#### APPEAL SUMMARY

Appeal ID: 20425	Project Address: 570 NE Tomahawk Island Dr	
Hearing Date: 5/22/19	Appellant Name: Jack Lyon	
<b>Case No.:</b> B-011	Appellant Phone: 503-805-1818	
Appeal Type: Building	Plans Examiner/Inspector: Brian McCall, John Cooley	
Project Type: commercial	Stories: 1 Occupancy: S-1, F, B Construction Type: V-B and II-B	
Building/Business Name: Sundance Marina	Fire Sprinklers: Yes - Fully	
Appeal Involves: Erection of a new structure,Reconsideration of appeal	LUR or Permit Application No.: 17-199693-CO	
Plan Submitted Option: pdf [File 1] [File 2]	Proposed use: Boat Storage

# Sundance Marina

# Engineering Judgement Report 2-Hour Exterior Wall

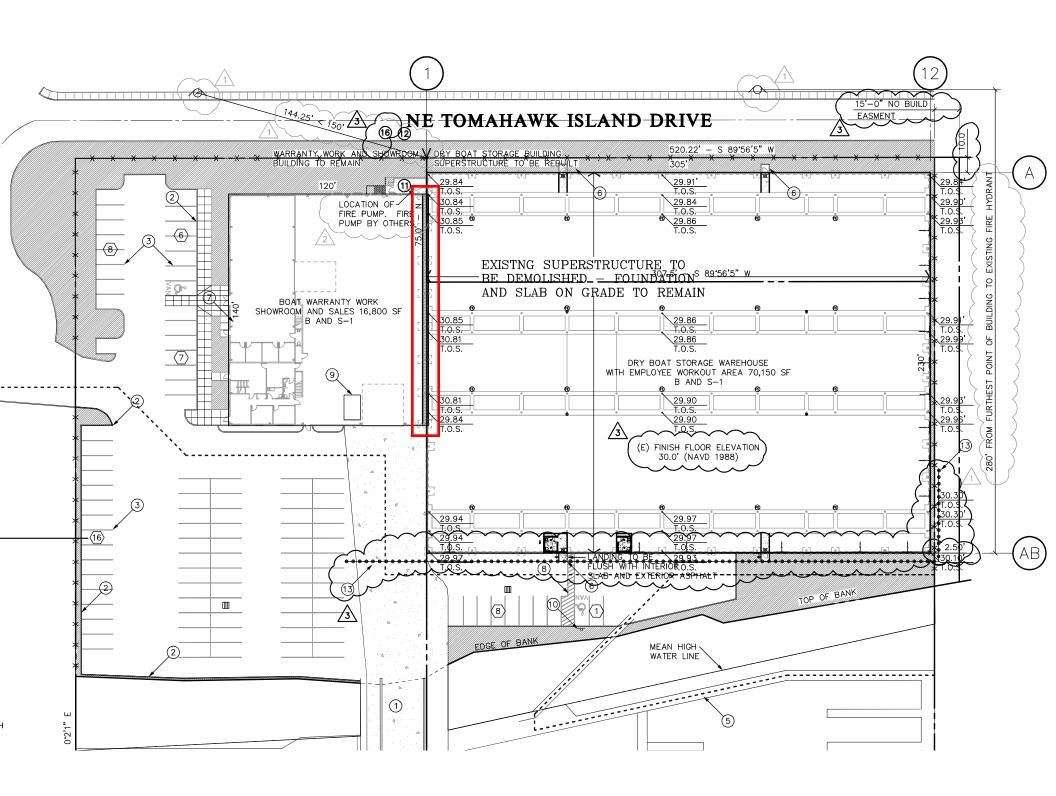
• •	
Code Section	Table 602
Requires	Existing building to remain (Type V-B; steel building with wood framed partial second floor) and New building (Type II-B; Steel building) will each be 6" from assumed property line. Both walls along the assumed property line are required to be 2hr rated.
Proposed Design	The proposed mineral fiberboard fireproofing provides the required rating. See Fire Engineer's evaluation report attached.
	RECONSIDERATION TEXT
	Following discussion with Corey Stanley we add the following clarifications:
	The two buildings are separated by a 12" air space
	The separate 2hr rated exterior walls are connected only by flashing at the top of the shorter wall.
	Neither of the two 2hr rated walls are load bearing
	Both buildings will now be sprinkled per NFPA 13
Reason for alternative	The new building is a re-construction of an existing building on the original foundation. Erecting the

new building 12" from the existing building leaves too little space for conventional drywall assemblies to be constructed.

exposure to weather by sheet metal siding above the shorter building.

The mineral fiberboard fireproofing provides equivalent fire protection and is covered from

Alternate 2 hour exterior wall assembly with engineering analysis: Granted provided the Albi Driclad mineral fiberboard installation detail is provided on the City approved plans.

Figure 1: Proposed exterior wall assembly.

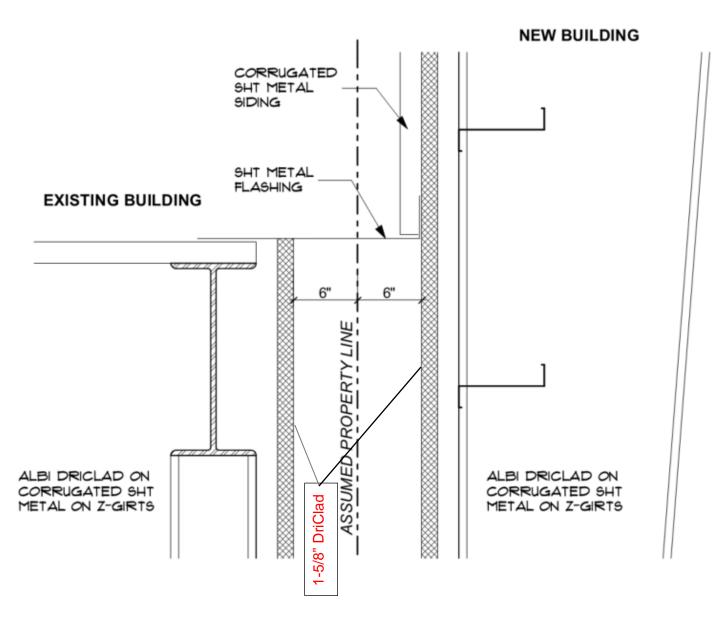
The existing building is of Type V-B construction. The modified exterior fire wall is non-load bearing with 1-5/8" Albi Driclad mineral fiberboards connected to the existing metal siding (Figure 1). The wall assembly has a 6" distance from an assumed property line. Horizontal and vertical metal flashing will protect the DriClad material from the elements.
